## **Appendix B-2: Additional Correspondence from Agencies about the EA and Draft Submissions**

**Subject: Review of Submissions Report for the Dalton Power Project (MP10\_0035)**

**RE: RESPONSE TO SUBMISSIONS FOR DALTON POWER PROJECT (MP10\_0035)**

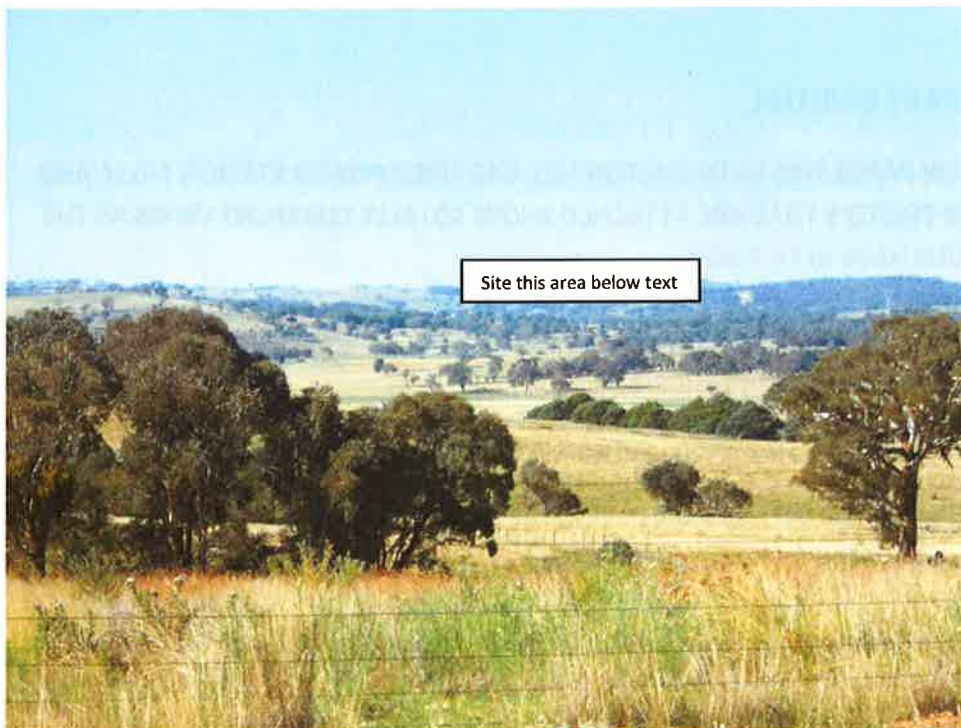
My photoFigure 1 Northern residents Dalton above.....please check against ea photo 1 it was taken past intersection in for ground.

EA photo was taken as low as possible, through a small tree and out of residential area. My photo will show the truth. also note ea photo's taken Dalton side look to me to be compressed in height to hide the real truth, and all heavy cloud cover to hide landscape. Andrew and leslie bush property.

MY PHOTO ABOVE WAS TAKEN FROM THEIR VERANDAH ANDREW & LESLIE BUSH PROPERTY  
FELLTIMBER ROAD DALTON ALSO NOT 4wd RUGBY ROAD..... NOT BEVENDALE STREET AS STATED IN  
EA
